METROPOLITAN GOVERNMENT OF NASHVILLE AND DAVIDSON COUNTY

STAFF RECOMMENDATION 1718 Greenwood Avenue February 18, 2015

Application: New construction-infill
District: Eastwood Neighborhood Conservation Zoning Overlay
Council District: 06
Map and Parcel Number: 08302027500
Applicant: Urban Development Group, LLC
Project Lead: Paul Hoffman, paul.hoffman@nashville.gov

Description of Project: New construction of a two-family residence.

FRONT ELEVATION

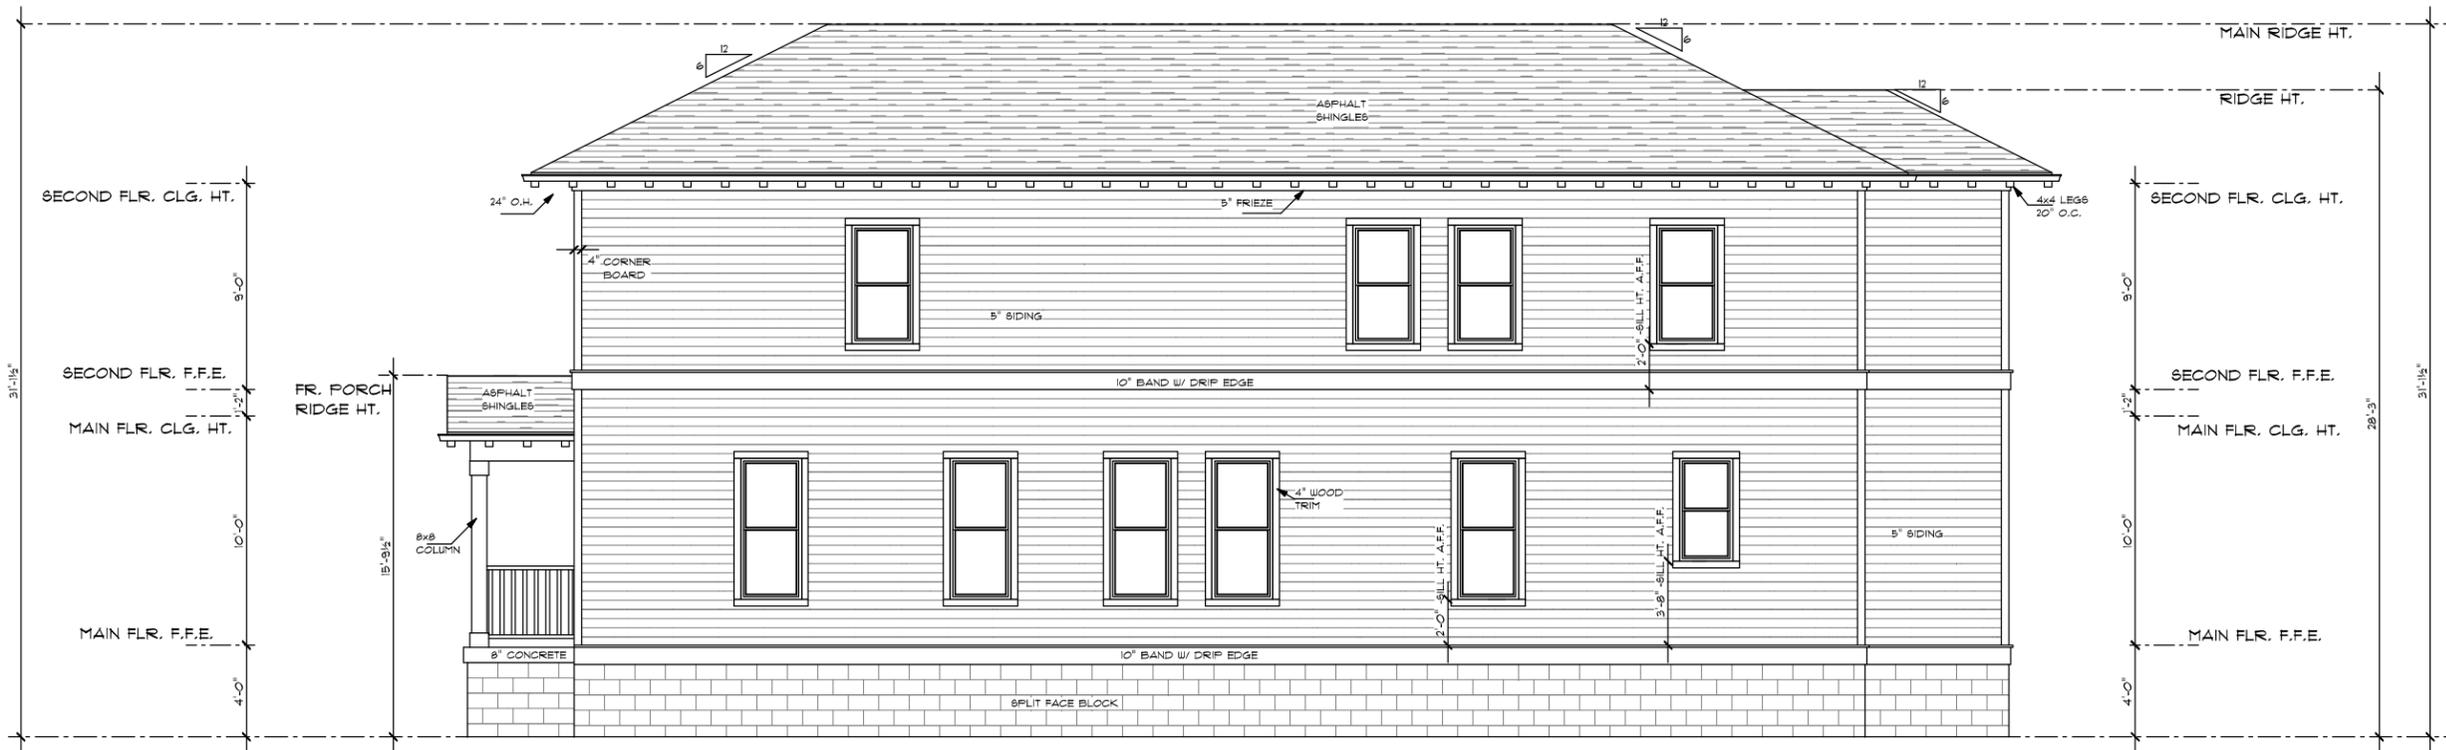
Orientation: A porch for each unit addresses the street, with a shared walkway leading to the driveway. The porches will be four feet, ten inches (4'10") deep. The design guidelines recommend a porch be at least six feet (6') deep. Staff requests the porches be increased to at least six feet (6'). Vehicular access will be via a shared driveway to the left of the new building. There is an existing curb cut on the right side of the lot; this curb cut will be removed and a new one added to the other side, for the driveway. Parking for both units will be at the rear. The proposed infill is oriented to Greenwood Avenue appropriately. With the condition that the porches are made six feet (6') deep, the project meets section II.B.1.f.

1. The porches are increased to be at least six feet (6') deep;
2. A window opening is added to the second story of both side elevations;
3. The finished floor height shall be consistent with the finished floor heights of the adjacent historic houses, to be verified by MHZC staff in the field;
4. Staff approve the roofing color, windows and doors prior to purchase and installation;
5. The HVAC shall be located behind the house or on either side, beyond the midpoint of the house.

LEFT ELEVATION

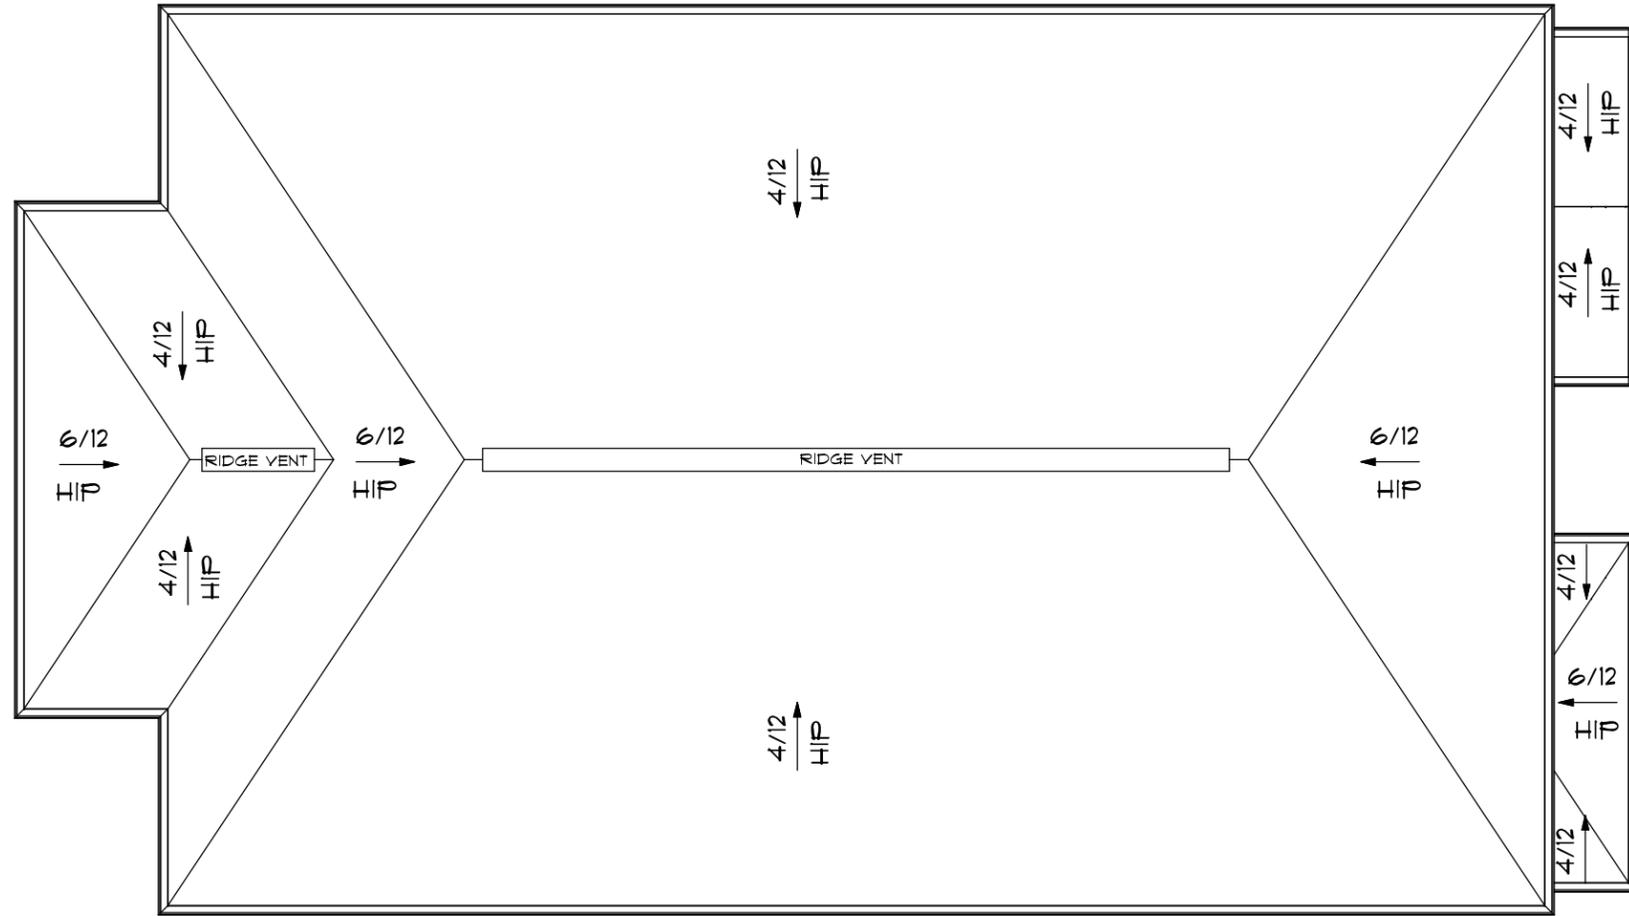
Proportion and Rhythm of Openings: The windows are all approximately twice as tall as they are wide, meeting the historic proportions of openings. The largest expanse of wall space without a window or door opening is eighteen feet (18') on the side elevations. Staff requests a window opening be added to break up that expanse of wall area. With this condition, Staff finds the project's proportion and rhythm of openings to meet Section II.B.1.g.
